ADDENDUM NO. 2

February 9, 2026

Southport High School Addition & Renovation Phase 1 (Activity Center Addition & Wrestling/Center Plant Renovation)
971 E. Banta Road
Indianapolis, IN 46227

S542

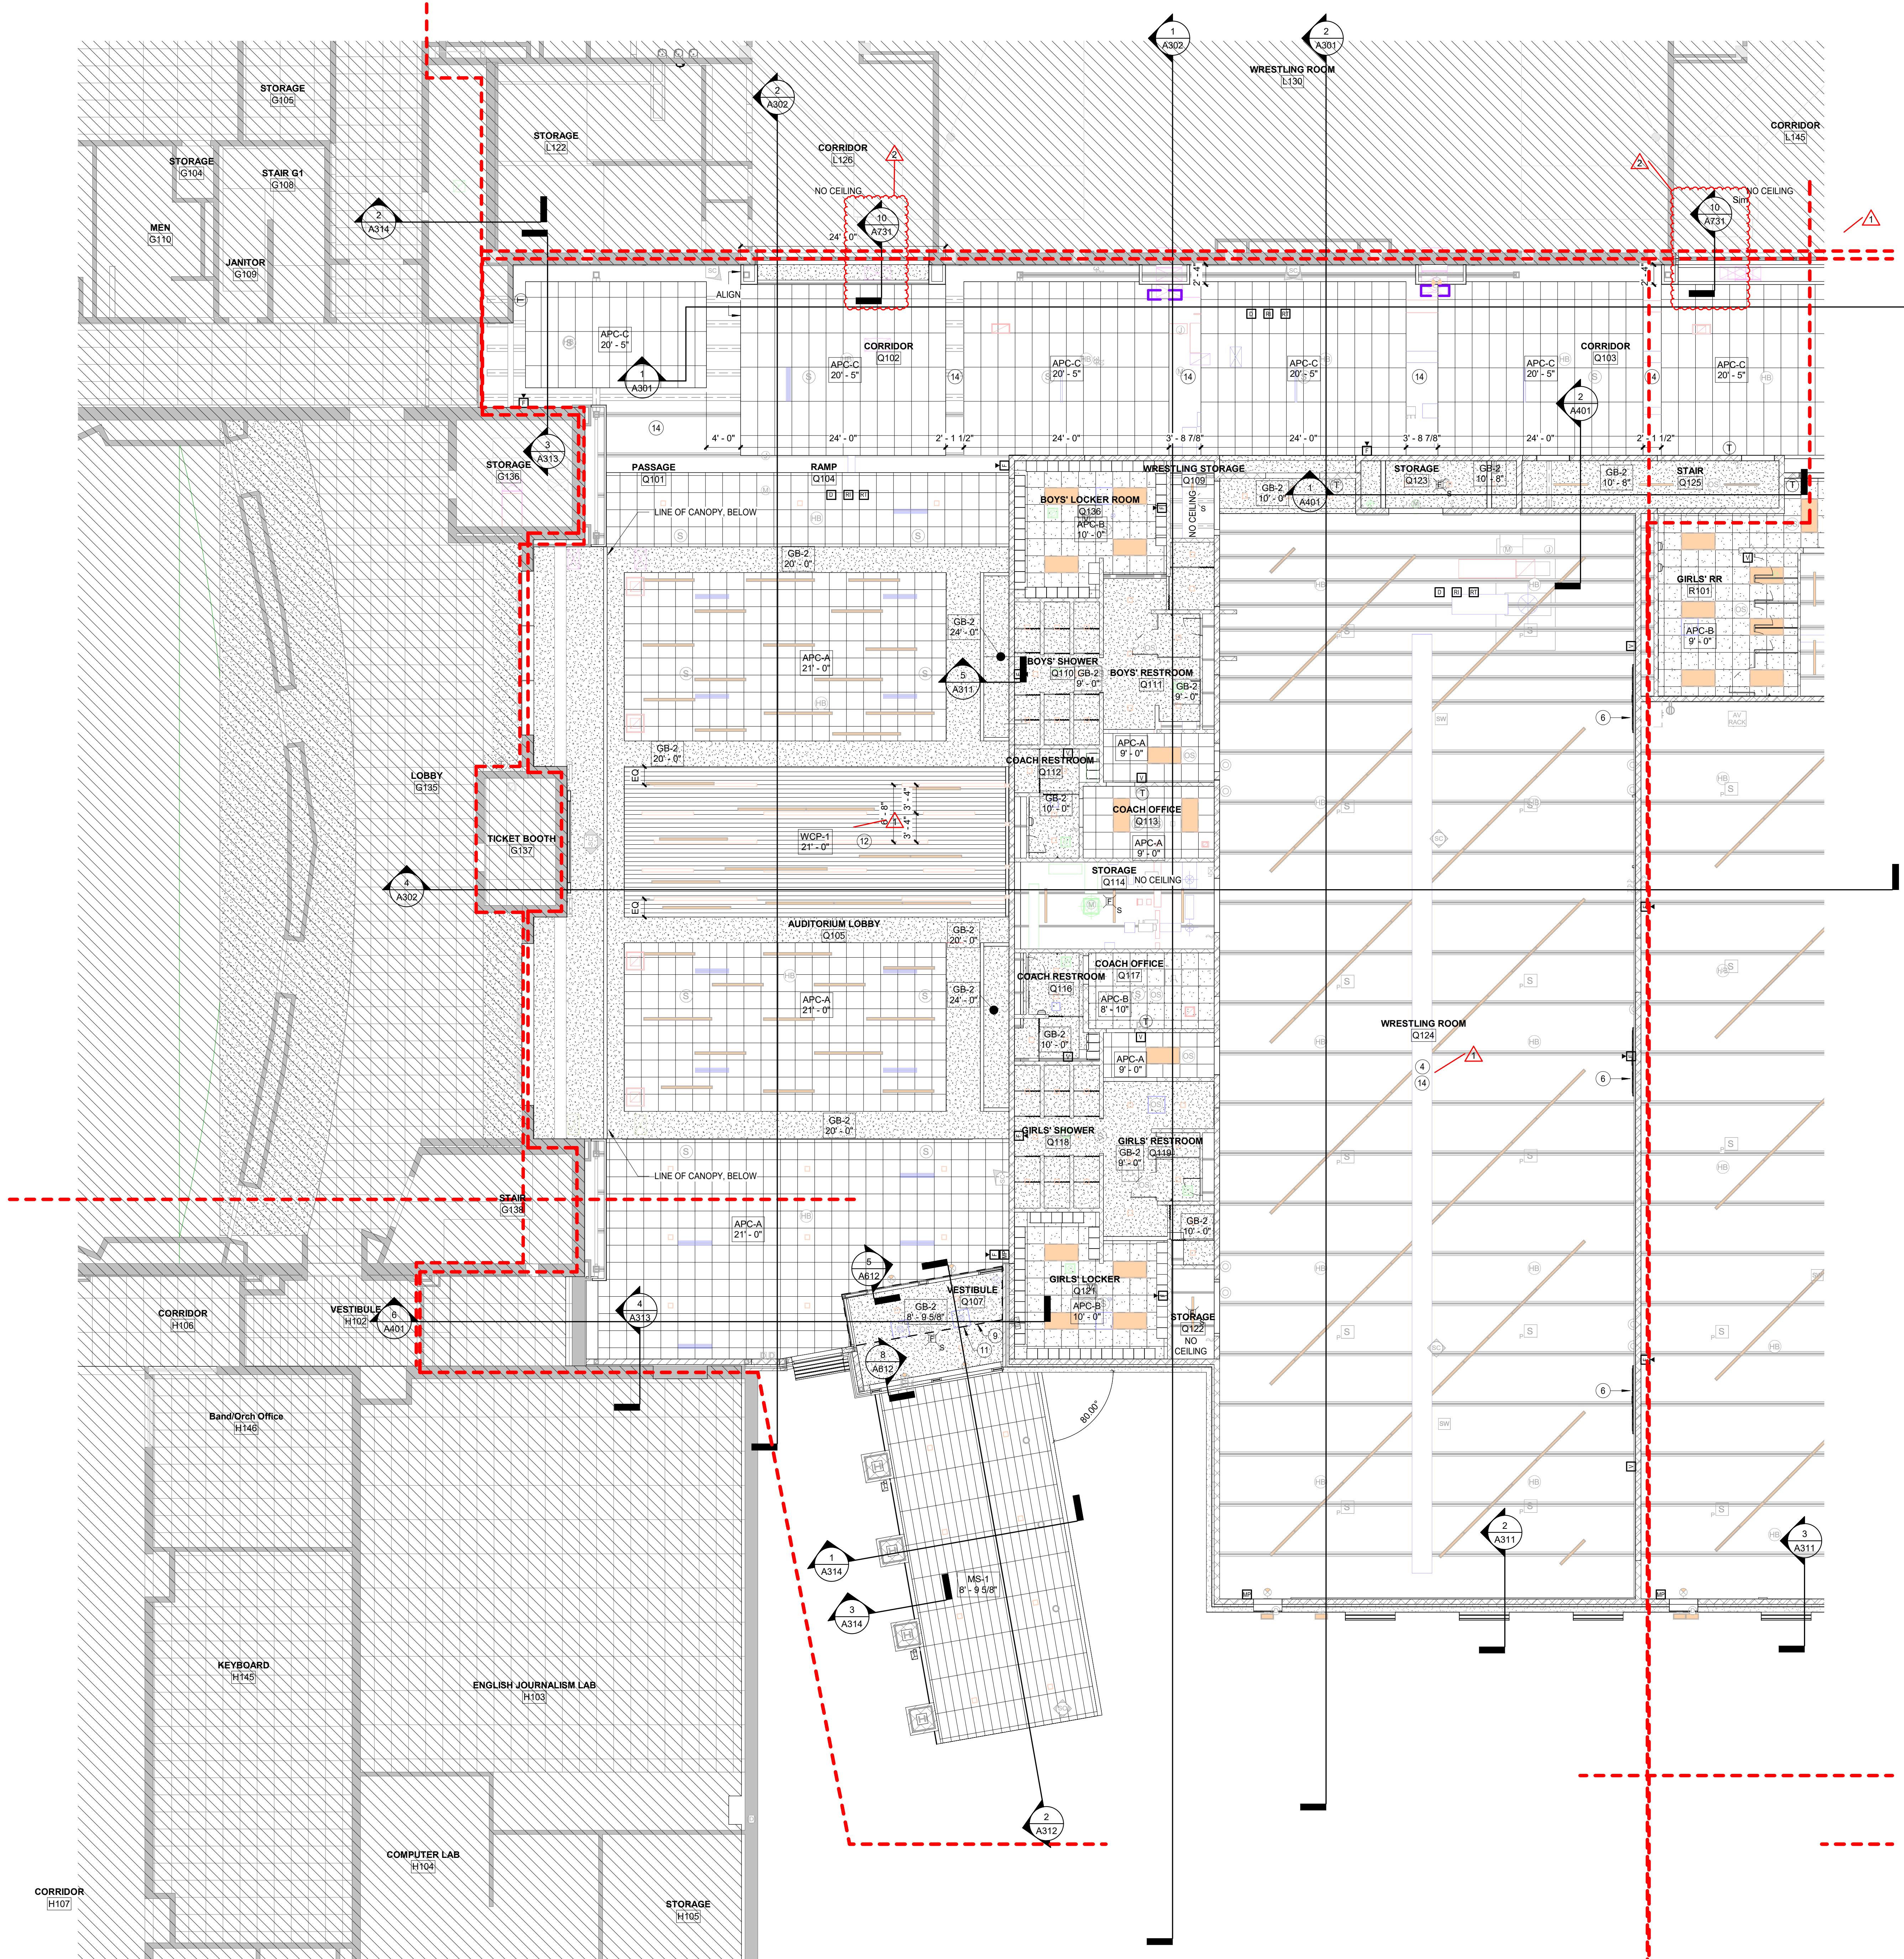
Change: Updated details, 3, 5, & 6.

- Changed roof truss bearing from bottom bearing to top bearing to 3/S524.
- Provided axial loading to roof truss to 5/S524.
- Changed roof truss bearing from bottom bearing to top bearing and added axial loading to the roof truss to 6/S524.
- Added thickened slab.

3 Elevation Ph1 South (Clerestory)

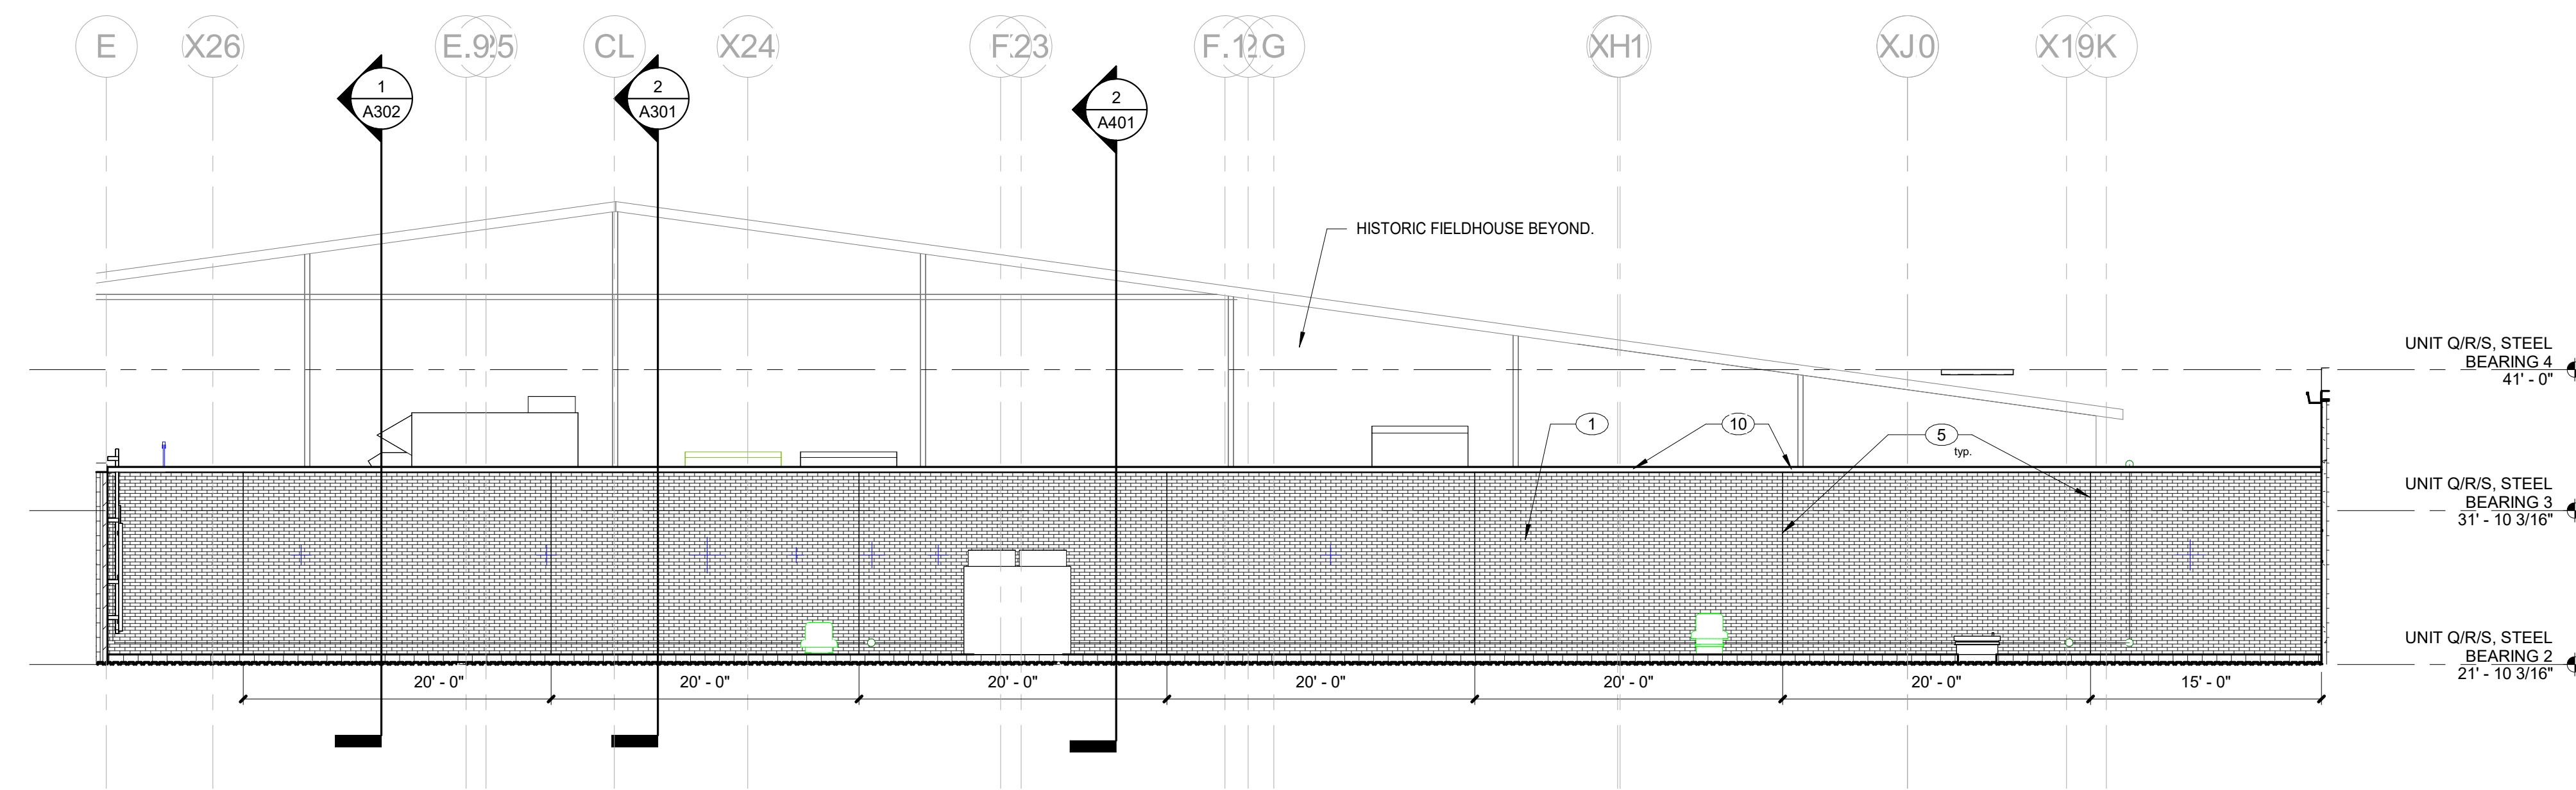
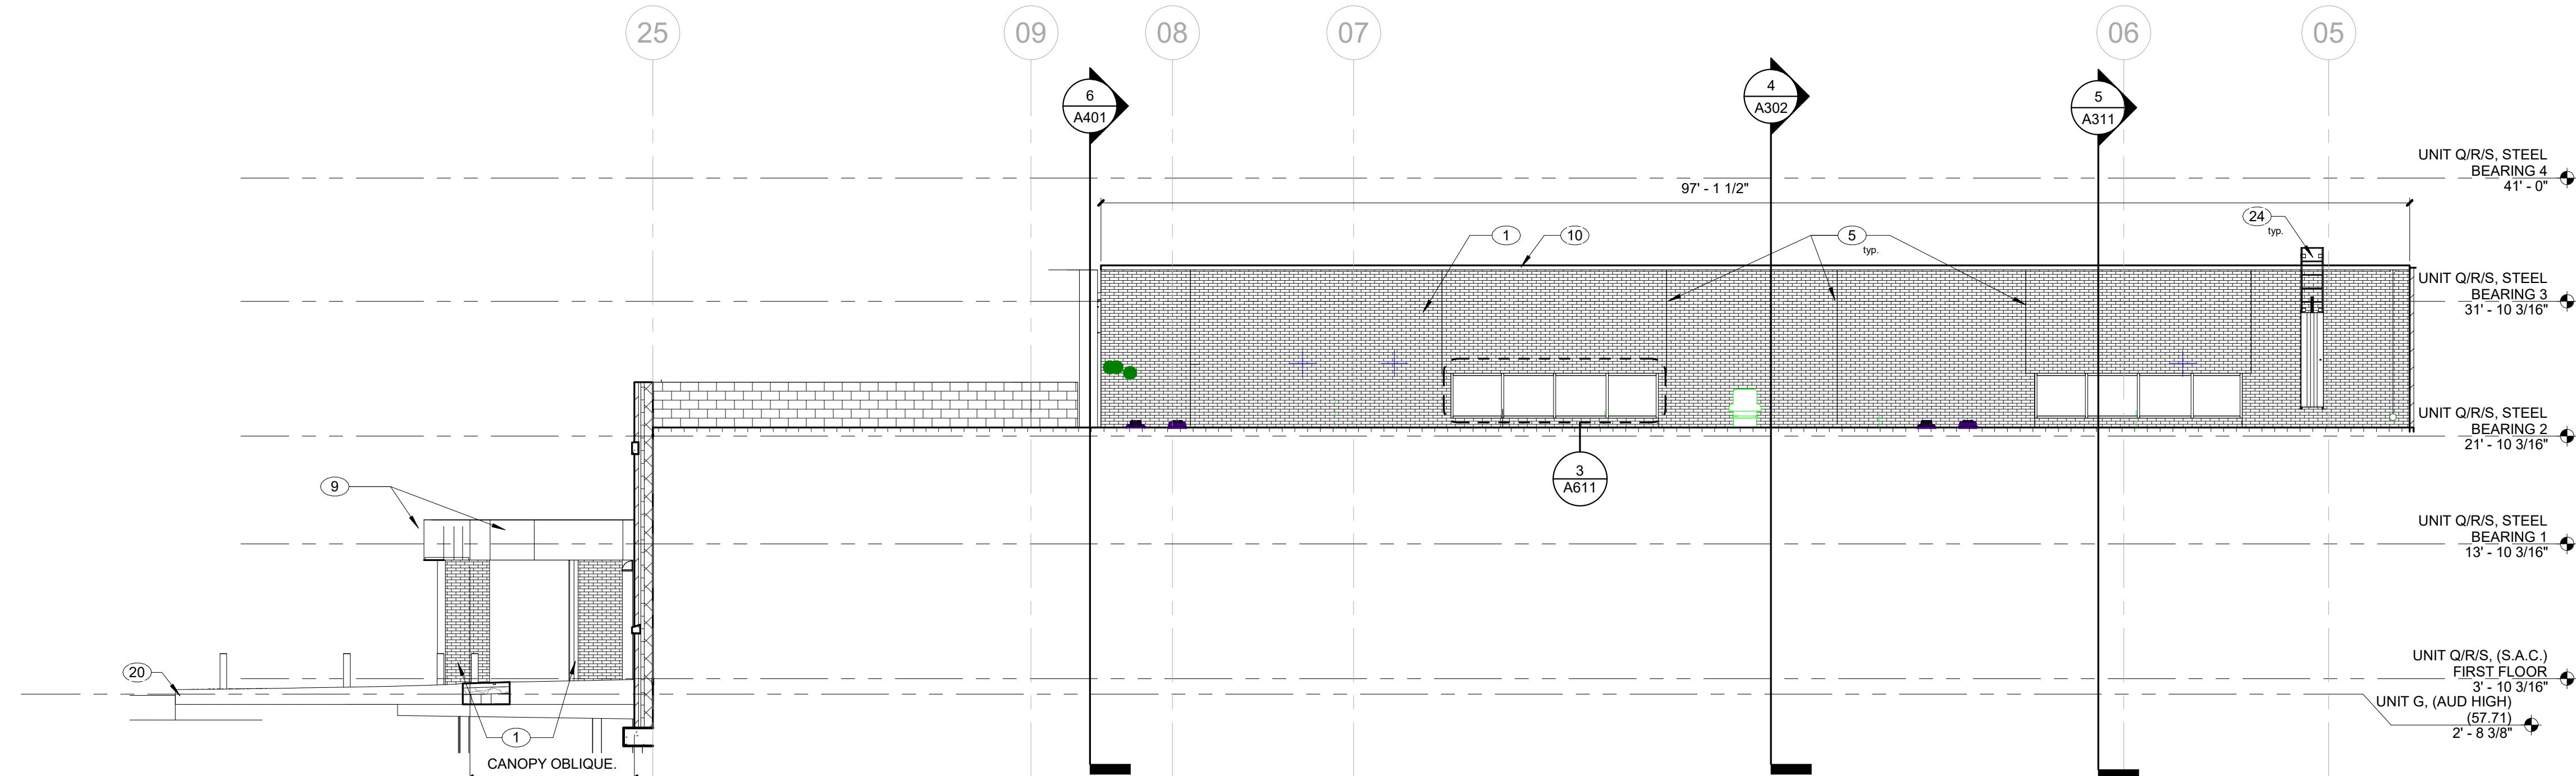
- 2.6, L says reglets are to be cast into the precast walls
- Detail 2/A503 says reglets are to be saw-cut into precast panels
- Please clarify the reglet intent

Response: Cast reglets into the precast panels.
